HOSHIZAKI AMERICA, INC.

SERVICE BULLETIN

SB12-0002R2

SUBJECT: C-100B Reservoir

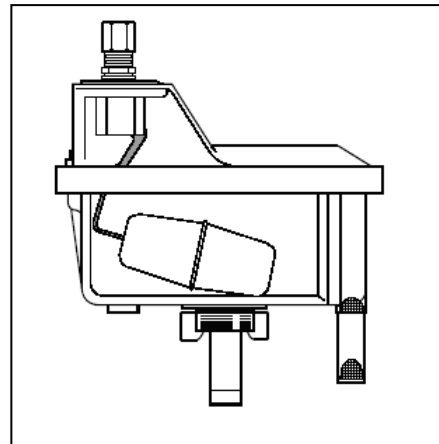
The reservoir assembly for the C-100BAE series Hoshizaki part number 4A4369-01 is no longer available from Hoshizaki service parts. Our inventory has been depleted and we can no longer purchase this part. An exact replacement part is available through McMaster Carr.

The valve and reservoir assembly part number is #7973K48.

*Note: The HS-5060 cannot be used on C-100BAE units. The C-100BAE must use the reservoir type shown above.

The same reservoir is used on C-100BAF series models up to serial number A1. In the past, part number 4A4369-01 subbed to kit HS-5011 however this kit is no longer available due to the unavailability of reservoir parts. A conversion kit (HS-5060) has been developed for the C-100BAF series with serial numbers up to A1. Serial numbers A2 and after used a different reservoir and water circuit. See the C-100BAF Parts Manual for part numbers used on series A2 and after.
